Cleveland National Forest Power Line Replacement Projects

To: Lisa Orsaba, California Public Utilities Commission (CPUC); Allison Rice, Dudek
From: Kirstie Reynolds, San Diego Gas & Electric Company (SDG&E)
Date: May 7, 2020 (Revised May 29, 2020)
Re: Cleveland National Forest Power Line Replacement Projects, Phase II of Circuit 440
Minor Project Refinement Memo

Note: The Existing Cable Replacement components were inadvertently omitted from the Proposed Project data.

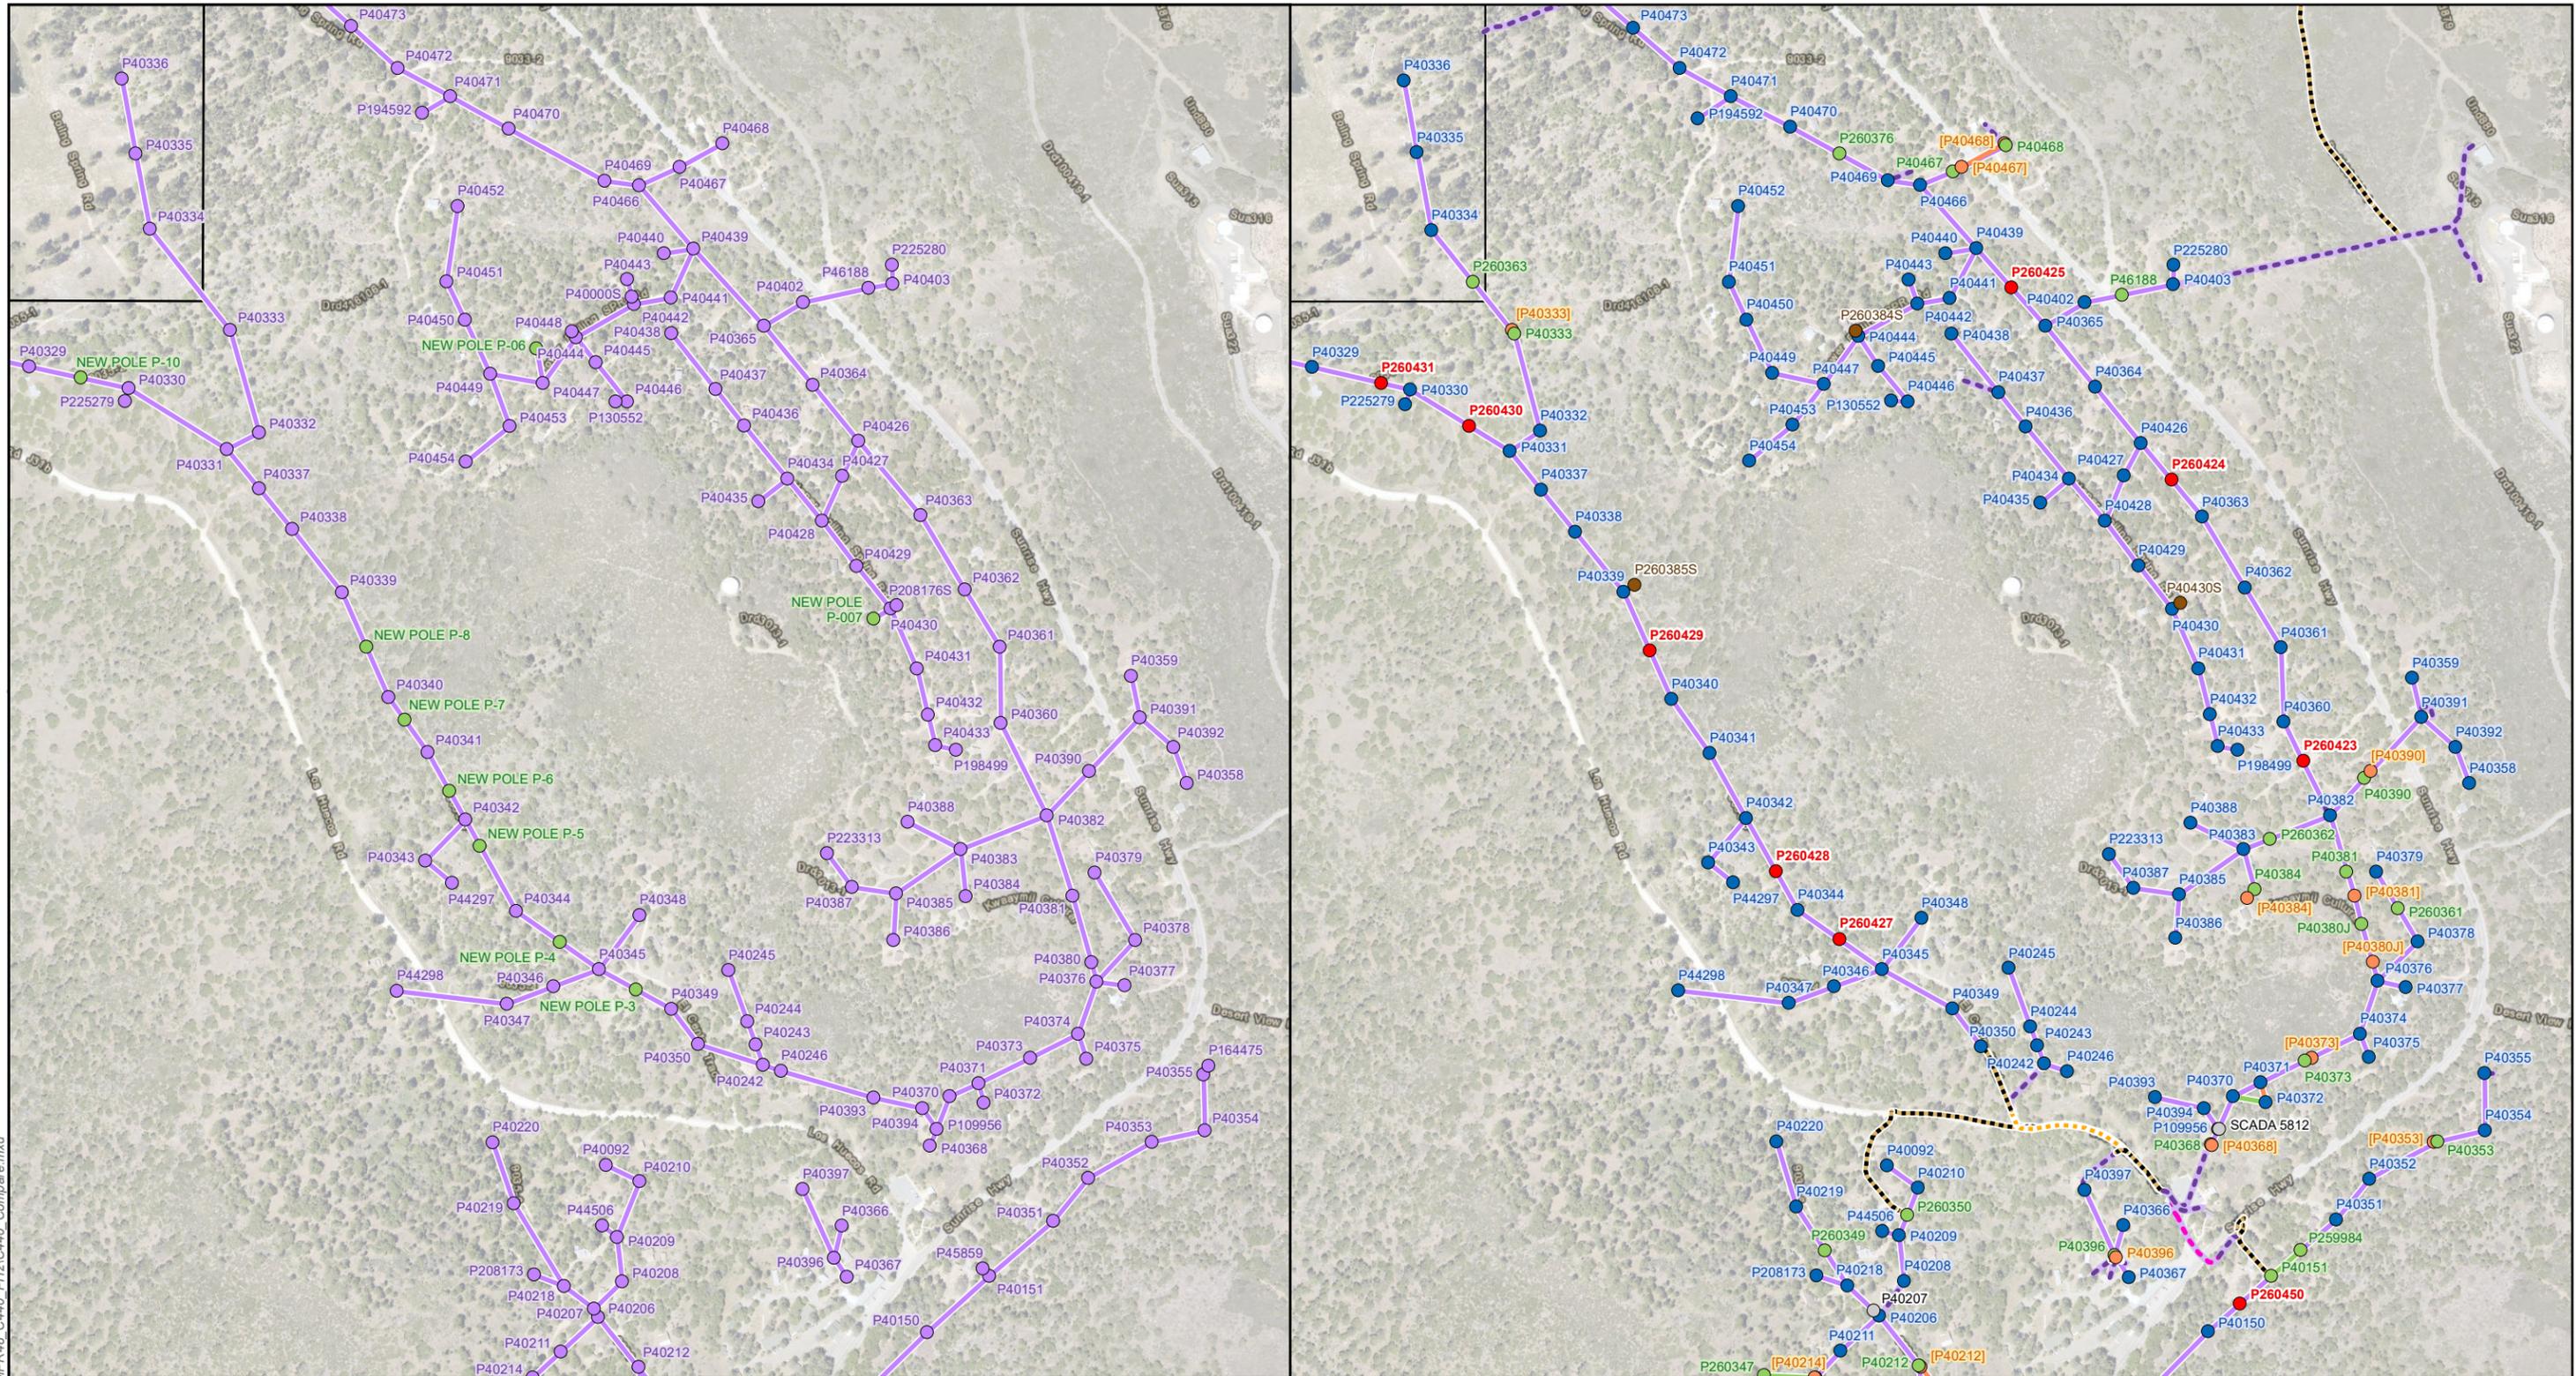
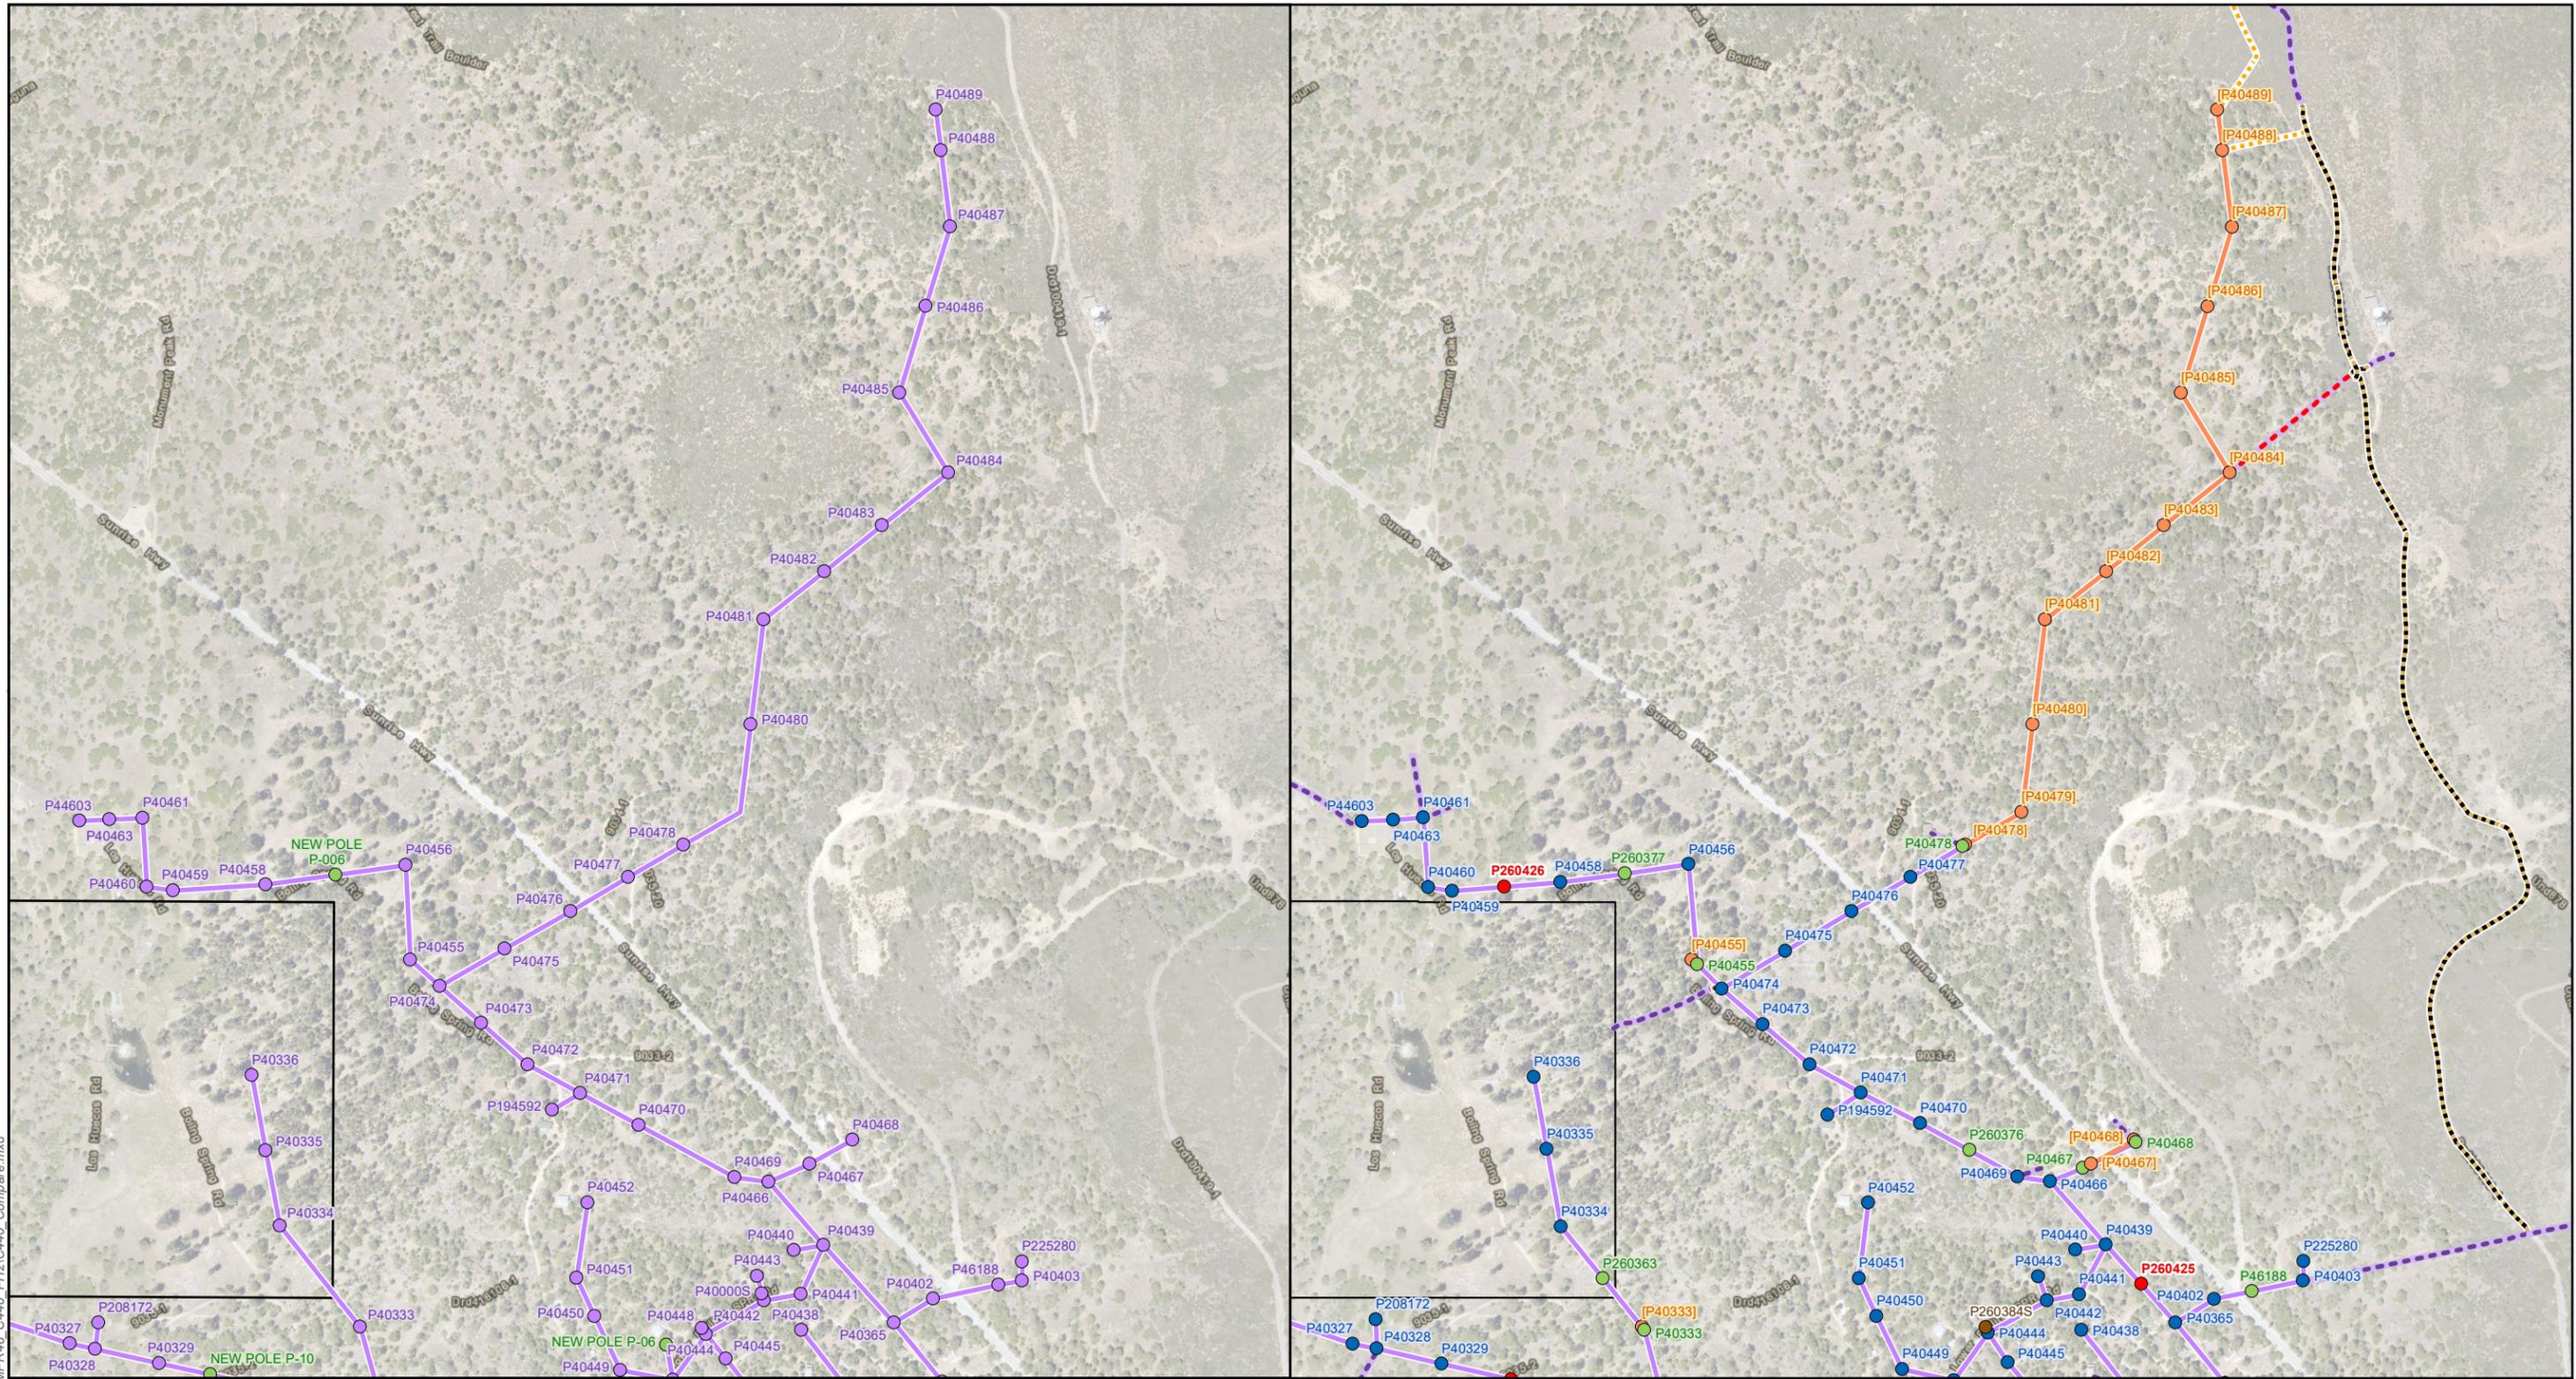
- Undergrounding along Sunrise Highway was stopped north of Mount Laguna Drive due to an ethnographic village site that was identified by the USFS. To reduce impacts to this significant cultural resource site, a portion of the existing overhead line west of Sunrise Highway will be removed and rerouted on the east side of Sunrise Highway as new overhead.

- Due to concerns expressed by the USFS regarding subsurface resources (i.e., hydrology) and the potential to create a dam effect that prevents water flow in the area, the final design includes the overhead rebuild, rather than undergrounding, of the existing overhead parallel to Los Huecos Road.

- Near Little Laguna Lake, to prevent impacts to sensitive biological and cultural resources, the final design includes overhead rebuild rather than undergrounding.

- Due to concerns expressed by the USFS regarding biological resources, vernal pools, subsurface resources (i.e., hydrology), and the potential to create a dam effect that prevents water flow in the area, as well as potential impacts to sensitive cultural resources, the final design includes overhead rebuild instead of undergrounding within the existing road near the Laguna Campground.

A map comparing the Proposed Project to the final design for Phase II of C440 (i.e., NTP request #27) is attached at Attachment C: Phase II of C440 Compare Map. All underground components that were carried forward from the Federal Preferred Alternative are included under a separate header (Federal Preferred Alternative) in the legend for the final design. Table 1: Phase II of C440 Undergrounding Comparison displays the miles of undergrounding that was anticipated for the Proposed Project and Federal Preferred Alternative, and what is included in the final design.
